WILLIAMSON COUNTY, TEXAS CHANGE ORDER NUMBER: _ 5

Forest North Drainage Phase 3 Williamson County Project No. 3866

Change Order No. 5

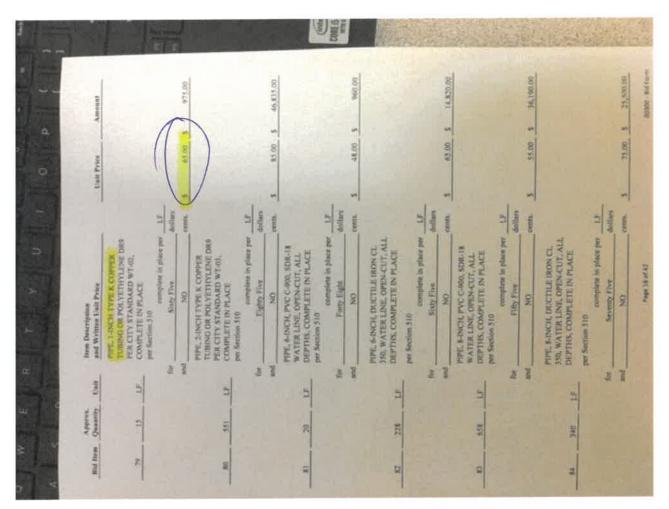
COPPER LISE INSTAU PRICING FOR SIMPLAR PROJECT = 65/LF

PRICE CONTRACTOR DUCTES HE HAS IN EXISTING

ITEM FOR PUC = 20/LF

DIFFERENCE PAIDTHRU
THIS C;O.

\$45/F
